Comments from anonymous Referee #3:

Legend: Referee comments in black, author comments in blue

This manuscript uses DOAS data collected in September 2020 in a polluted region in western Germany from airborne, ground, and car-based instrumentation to validate the set of TROPOMI L2 NO₂ products (both research and operational). The airborne datasets are first validated by the ground and car-based systems which then justifies the airborne use for validating TROPOMI. This paper fits the scope of AMT and will be valuable as a validation dataset for the TROPOMI NO₂ product. However, before publishing, this manuscript requires some minor technical corrections/clarifications as detailed below but more reflection toward conclusions drawn about improvements in the S5P PAL product and the impact of clouds. Detailed comments below.

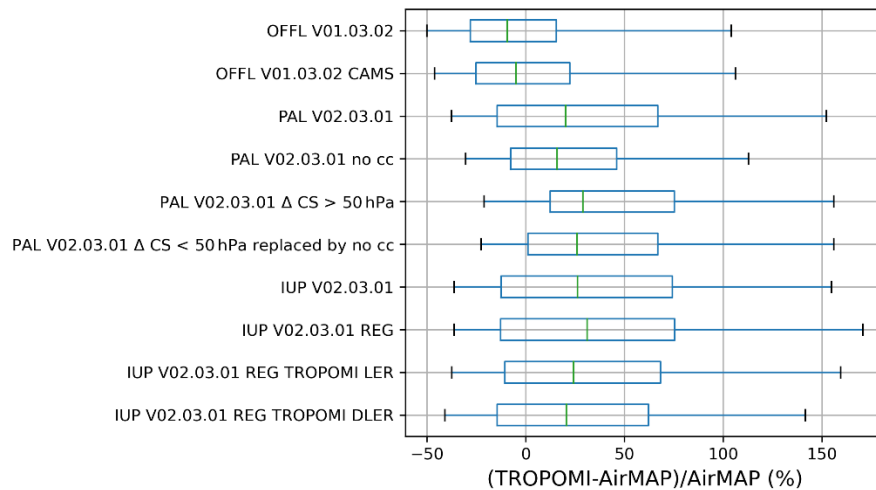
Most of the results in this work are too heavily based on the slope of the regression, which is not representing the complete behavior of the validation activity. Table A1 has at least median difference in % which actually in some cases contradicts the results of the slope (e.g., having a 21% higher column from TROPOMI as a median from S5P PAL V02.03.01.). Consider more in-depth analysis based on statistics other than slope for all intercomparisons.

Thank you for the comment. We have included the median differences given in Table A1 with some additional comments in the text analyzing the comparisons and added a Figure with Box-and-whisker plots summarizing the bias and spread of the difference between the different TROPOMI versions and AirMAP tropospheric NO₂ VCDs in the Appendix (see Fig. 1).

Figure 2: Scatter plots of AirMAP versus car DOAS tropospheric NO₂ VCDs. The AirMAP tropospheric NO₂ VCDs are retrieved with a VCD_{ref} of 1×10^{15} molec/cm² for both plots. The IUP car DOAS data are retrieved with (a) 1×10^{15} molec/cm² and (b) 1.5×10^{15} molec/cm².

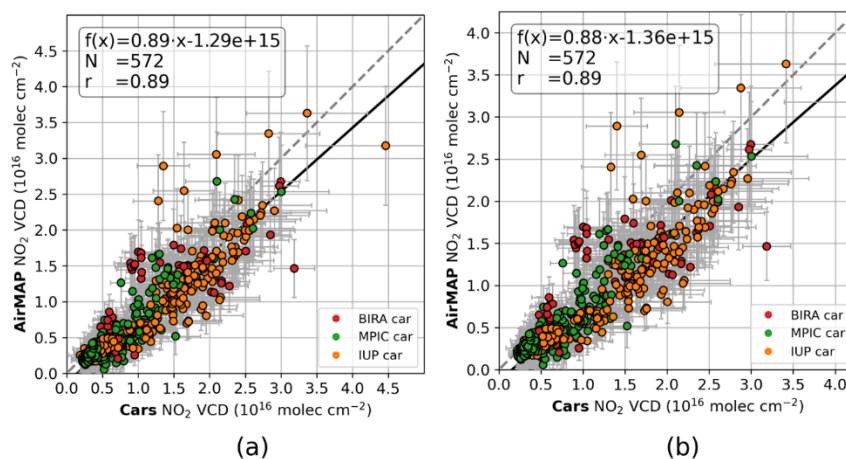
It is said that the reference VCD in the troposphere for AirMAP is $1e15$. One of the MAX-DOAS retrievals has a different value of $1.5E15$ but they are referred to as similar. It is different by 50% rather than similar. Please clarify these difference or explain them.

Could this reference assumption be the cause for a low offset between the car DOAS systems and the airborne dataset?

Thank you for pointing this out. Since there is no reason for using different reference values, we have decided to use the value of 1×10^{15} molec/cm² for both, the AirMAP and IUP car DOAS tropospheric VCD retrieval. The other car DOAS instruments do not rely on this value as they use dedicated measurements taken at lower elevation angle to directly estimate the tropospheric column in the reference measurement.

The influence of the mentioned difference of 0.5×10^{15} molec/cm² is not very large and cannot explain the offset between the car DOAS and AirMAP dataset, respectively only a very small part of it. Figure 2 shows scatter plots of AirMAP versus car DOAS comparisons. The AirMAP tropospheric NO₂ VCDs are retrieved with a $VCD_{\text{trop, ref}}$ of 1×10^{15} molec/cm² for both plots. The IUP car DOAS data are retrieved with (a) 1×10^{15} molec/cm² and (b) 1.5×10^{15} molec/cm².

Figure 3: Daily maps of TROPOMI and AirMAP tropospheric NO₂ VCDs. Red crosses mark the location over which AirMAP took the reference measurement. Pink crosses mark the TROPOMI pixel covering this reference location.

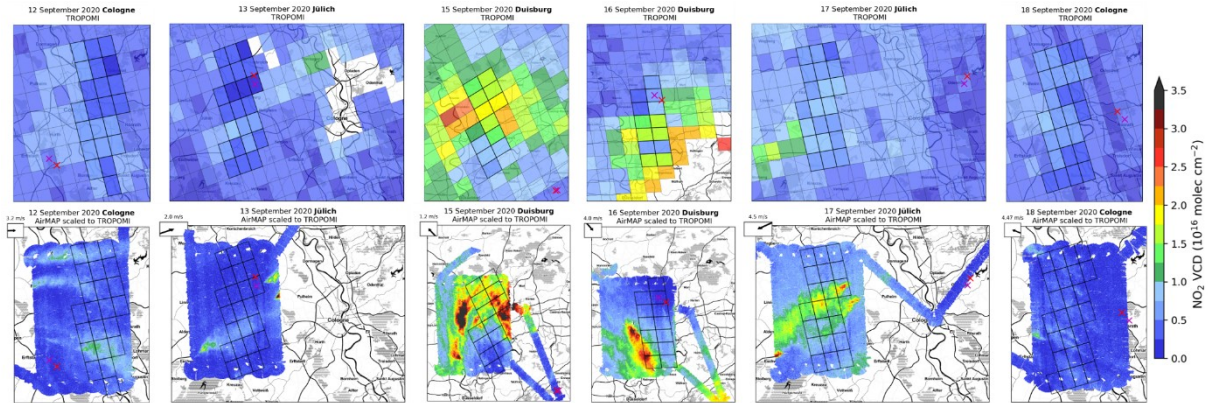
Can the reference value be justified with any other data from this work? (i.e., What does the CAMS model say the tropospheric amount is?)

Due to larger differences between the CAMS model and TROPOMI respectively AirMAP tropospheric NO₂ VCD in distribution and amount (see paper Fig. 8 and Fig. A1) we have decided not to use the CAMS model data for the determination of the VCD_{ref} . Instead we checked the TROPOMI tropospheric NO₂ VCD closest in time and space to the AirMAP reference measurement. Figure 3 shows the daily

maps of TROPOMI and AirMAP tropospheric NO₂ VCDs. The red cross marks the location over which AirMAP took the reference measurement. The pink cross marks the TROPOMI pixel covering this reference area. Using these TROPOMI observations would yield in a VCD_{ref} of $4.1 \pm 1.5 \times 10^{15}$ molec/cm². Due to the time difference between the AirMAP reference measurement and the TROPOMI observation, variations are expected and often pixel with lower values can be found close to selected pixel.

Figure 5: NO₂ profile used in the SCIATRAN AMF calculations for the AirMAP measurement flights. The profile is based on WRF-Chem model runs and scaled to the typical boundary layer height during the measurement days around noon.

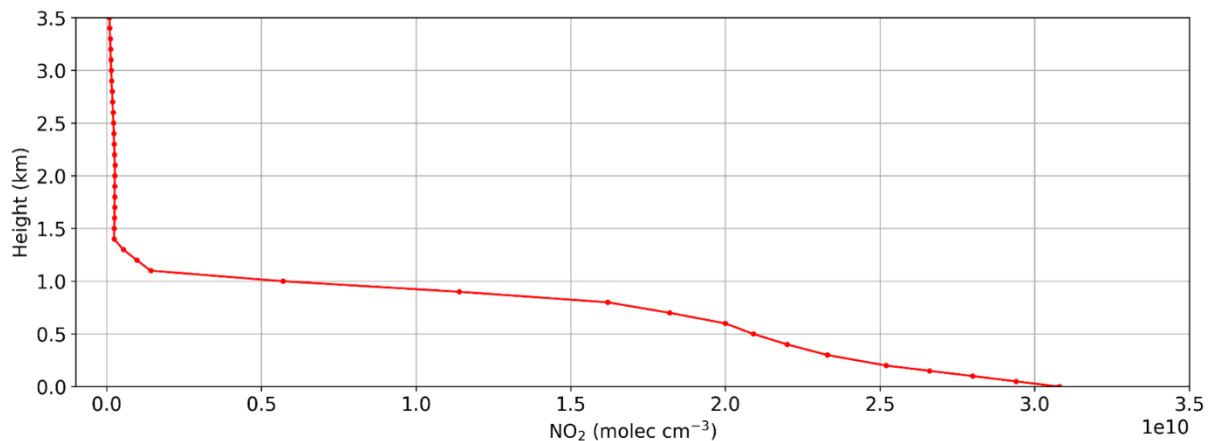
Can the authors justify why a 1km box profile used if CAMS analysis is available for these flights to provide a profile shape and what that assumption impact may be in the results? A 1 km box profile assumes that NO₂ is well mixed through that 1km boundary layer which has been demonstrated as not the case with in situ measurements from aircraft near strong sources (which is the case here in many of these flights). (e.g., <https://doi.org/10.1002/2015JD024203> and <https://doi.org/10.1525/elementa.2020.00163>). This paper also shows the impact of AMFs based on assuming a 1km box vs an urban profile atmos-meastech.net/3/475/2010/

Thank you for pointing out this mistake. This was an outdated information and was missed by us during correction phase. The SCIATRAN tropospheric AMF calculations used in the AirMAP VCD retrieval are not based on a 1 km box profile but are using a NO₂ profile based on an old WRF-chem model run scaled to the ERA5 boundary layer height, which reached typical values of 1 km around noon (see Fig. 5). This assumed profile is following very well the modeled and in-situ aircraft profiles from the DISCOVER-AQ campaign 2011 (Zhang et al., 2016) and the averaged urban NO₂ profile from CHIMERE model runs shown in Leitao et al. (2010). We have changed the text accordingly.

Figure 6: Distribution of AMFs calculated with the parameters of Table 1 for a wavelength of 350 nm (a) and 460 nm (b) for 90° VZA (dark color) and 30° VZA (light color).

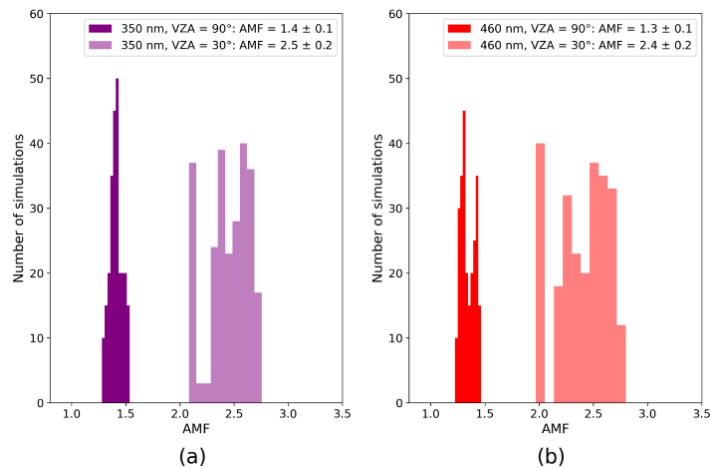
The MAX-DOAS measurement truck is different from the rest in that it measures in the UV rather than the visible wavelengths of the other retrievals. Is it realistic for their AMFs to be the same as the other systems?

Thank you for pointing this out. We did some radiative transfer calculations using the following parameters, which are adjusted to the ground-based and AirMAP comparison times around noon regarding SZA and typical albedo and AOT values found during the campaign measurement days. Based on these calculations the dAMF in the UV is closer to 1.1 instead of the assumed 1.2 (see Fig. 6). Thus, we recalculated the MAX-DOAS measurement truck VCDs, updated the AirMAP versus stations scatter plot and the AMF information in the manuscript.
